LAND USE APPLICATION SUMMARY

Property Location: 1505 W Lake Street
Project Name: Wells Fargo
Prepared By: Kimberly Holien, Senior City Planner, (612) 673-2402
Applicant: Lori Smith, Wells Fargo
Project Contact: Brian Reno, Stantec
Request: To construct a new 4,500 square foot bank building and modify an existing drive-through facility.

Alteration of Non-Conforming Use	To alter the existing drive-through facility
Variance	To exceed the maximum off-street parking requirement
Variance	To increase the maximum allowed height and area of wall signs
Variance	To increase the maximum allowed height of a freestanding sign from eight feet to 11.9 feet and to increase the number of freestanding signs from one to two.
Site Plan Review	For a new 4,500 square foot bank building

Figure 1: Proposed Parking

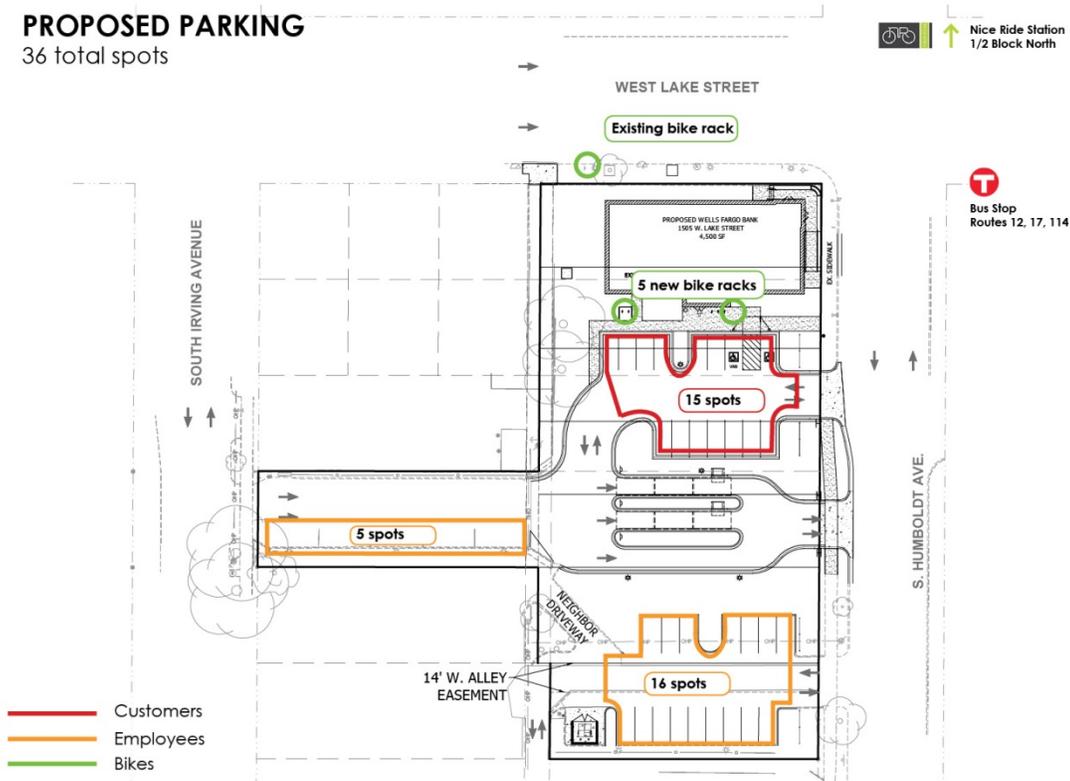
Wells Fargo proposes to use the southern half of its site for employee parking. As described above, the usability of this portion of the site is constrained by existing easements that facilitate access to neighboring properties. Wells Fargo proposes to use this portion of the site to designate 16 parking spaces for its employees. As part of its commitment to the neighborhood and the purpose and intent of the Pedestrian Overlay Zoning District, these parking areas would be fully screened by decorative railings and landscaping along Humboldt Avenue.

A NORTH ELEVATION

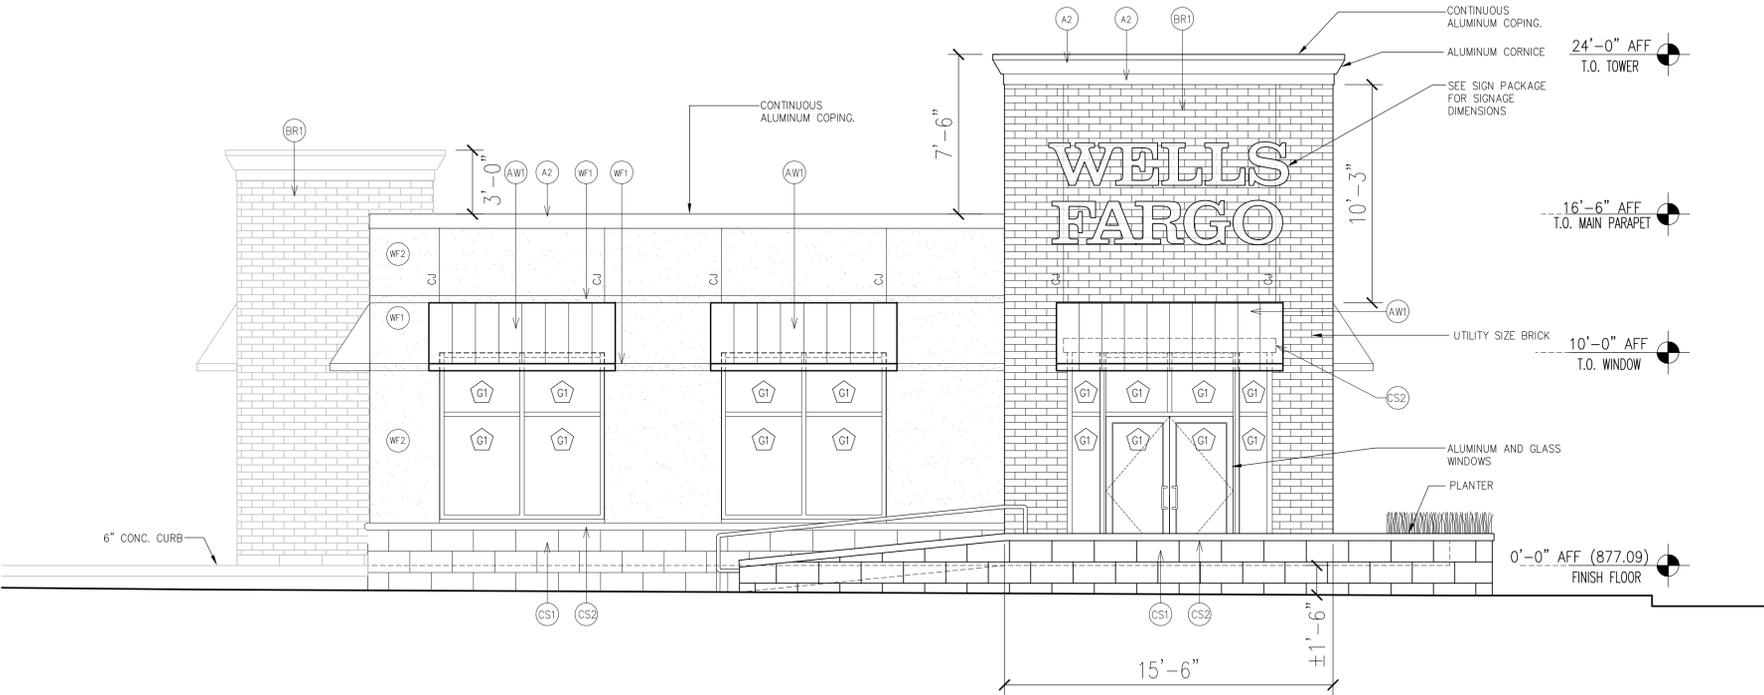
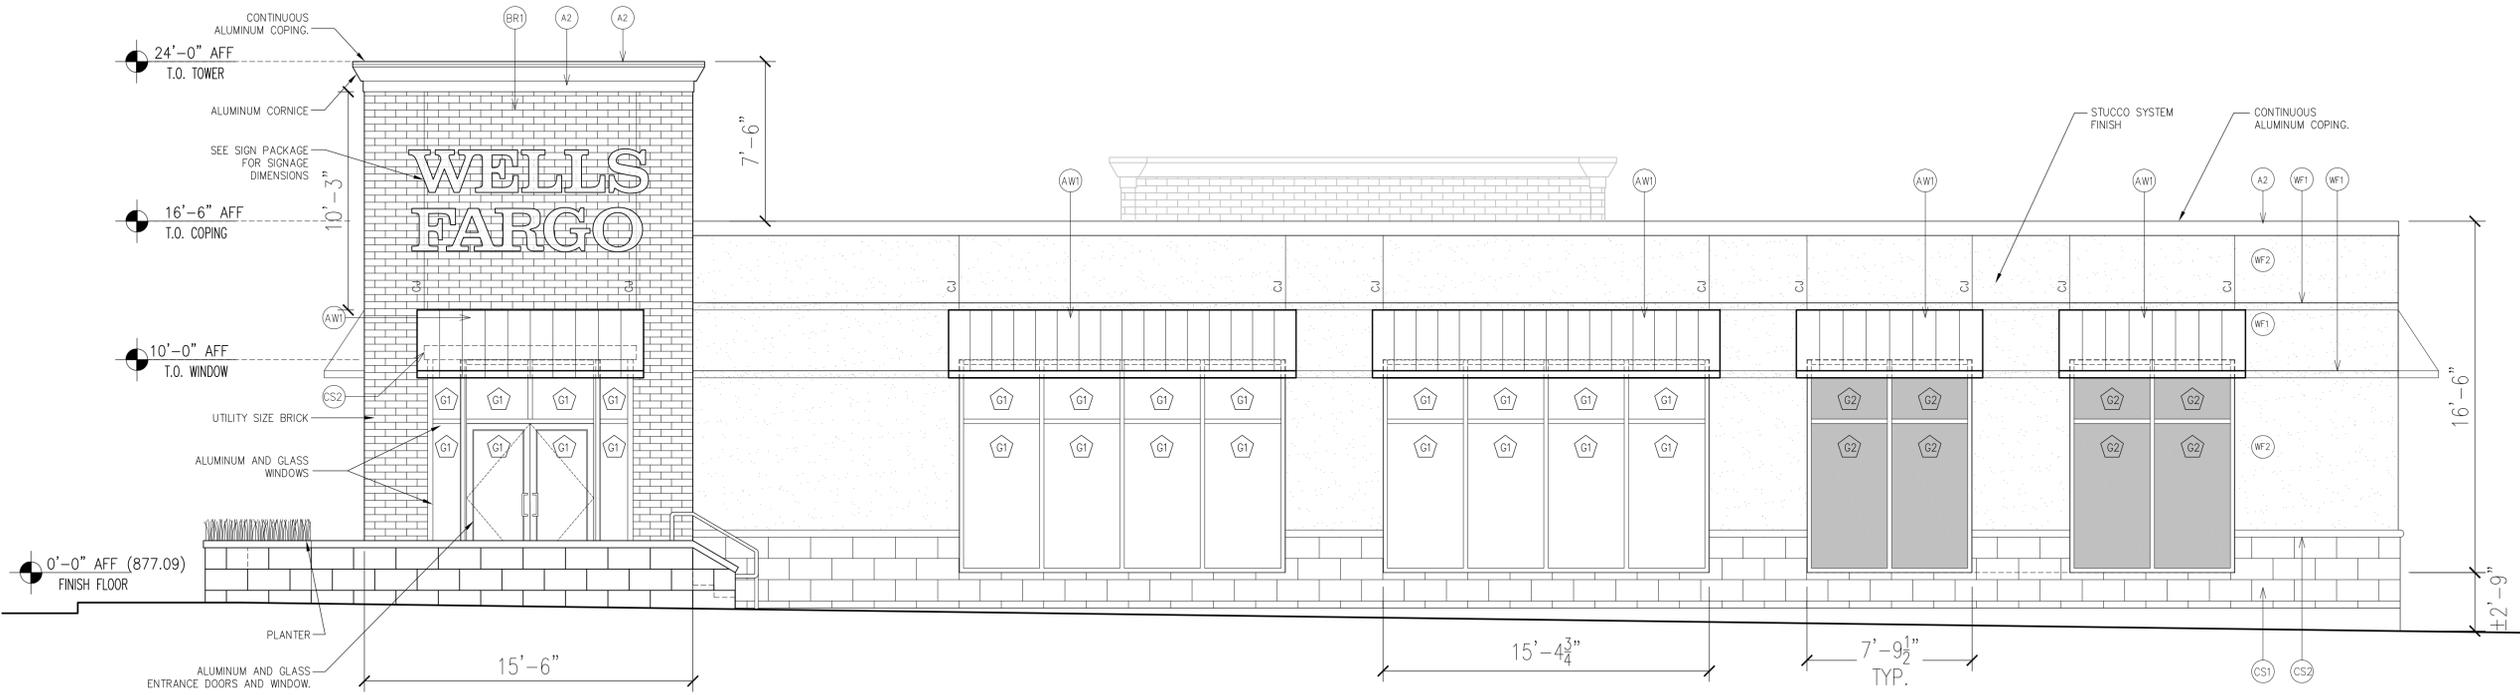
The applicant is showing wall signs on the north and east elevations that exceed the maximum allowance for height and area in the C1 district. A wall sign on the south elevation exceeds the maximum height

- All windows are required to maintain a visible light transmittance ratio of 0.6 or higher. Two of the windows on the north elevation and the only window on the west elevation are proposed to have a frost film applied to the interior due to the functions within this portion of the building. Staff encourages the applicant to re-work the floor plan to provide a use in the northwest corner that can accommodate clear glazing. This could be accomplished by switching the break room and the teller work room around.

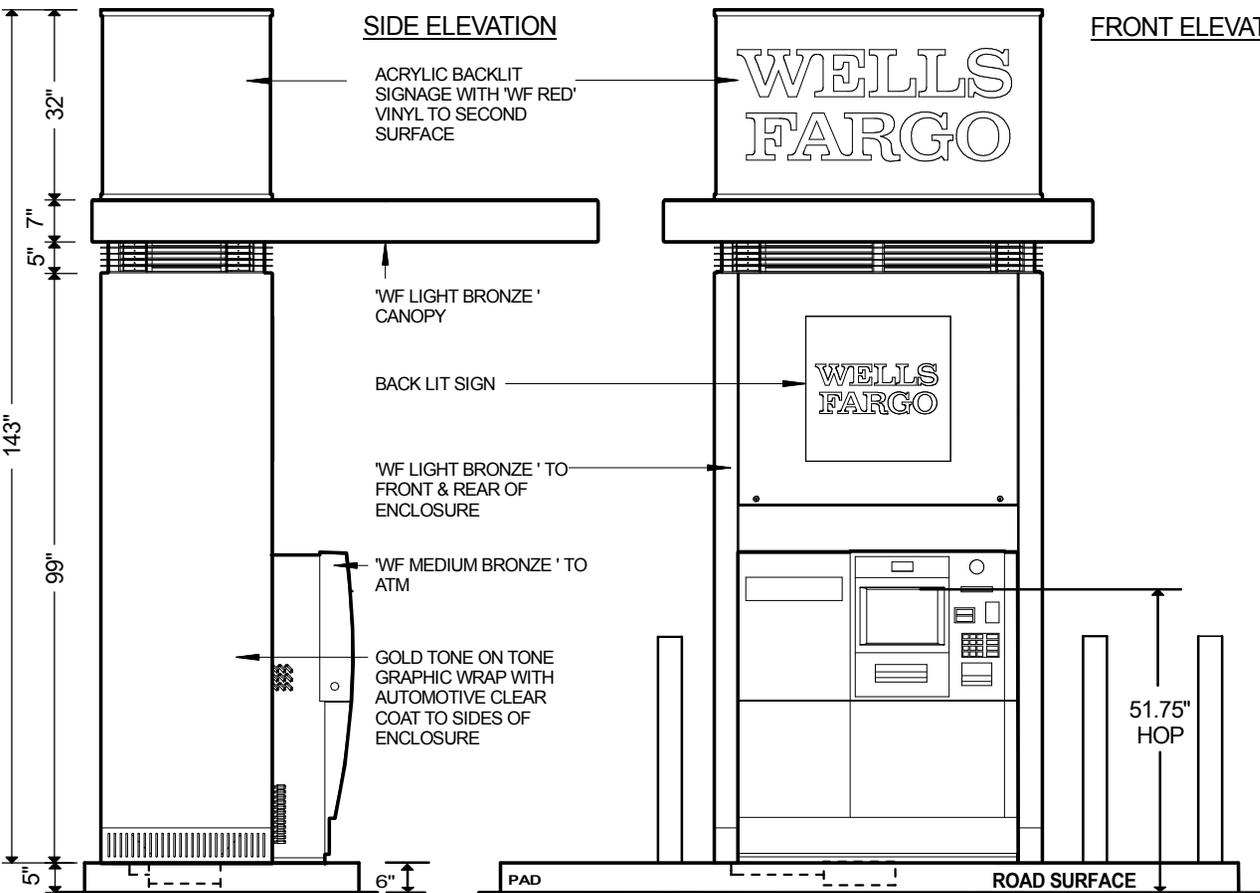
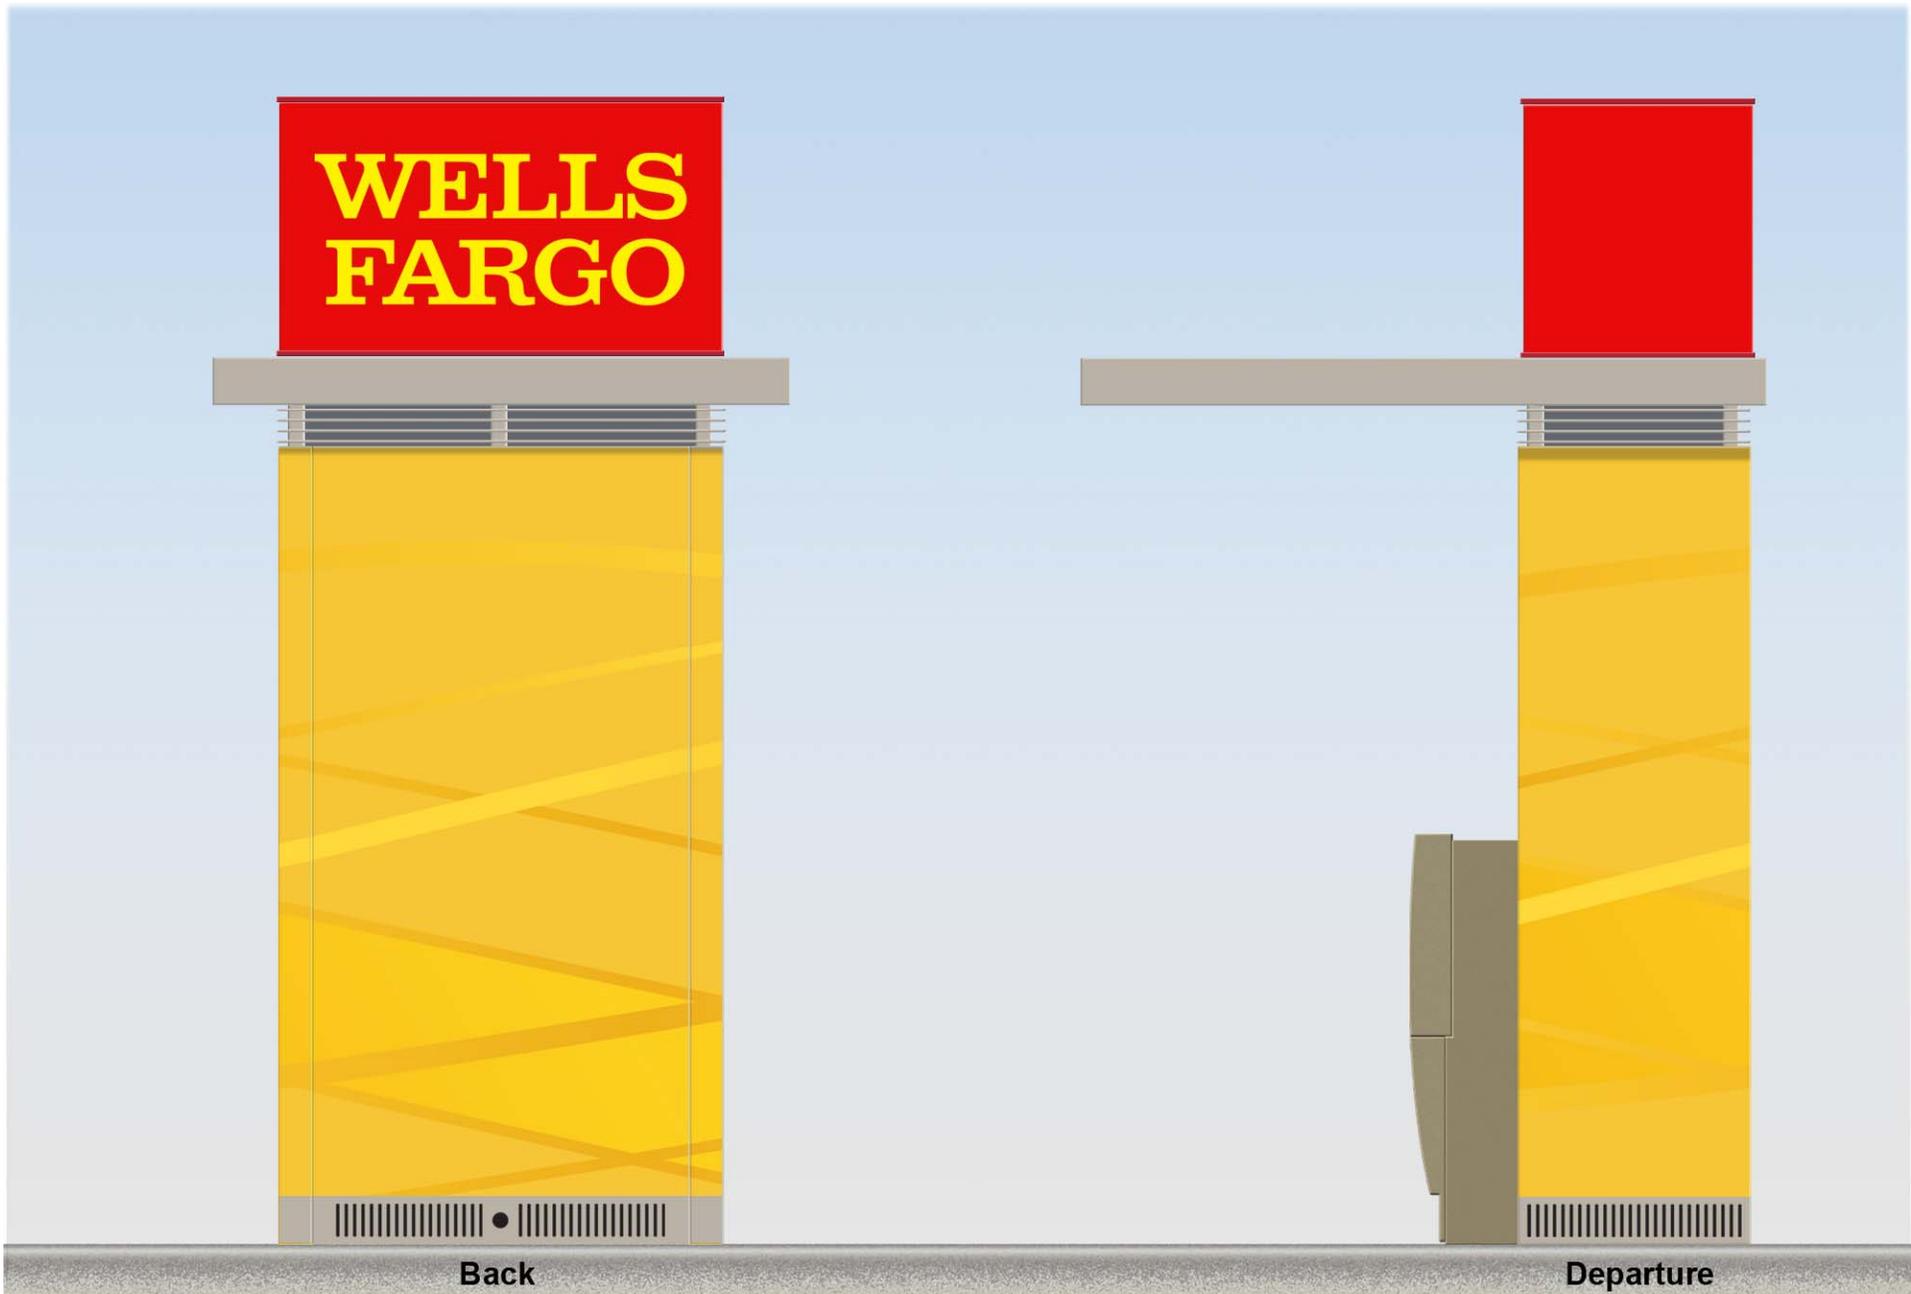
The proposed wall signs will be individual, internally illuminated channel letters. The ATM signs will be acrylic with vinyl on the surface. The plan notes that these signs are backlit, but the applicant indicated that this is not the case. In any event, staff is recommending that the signs at the top of each ATM be removed.
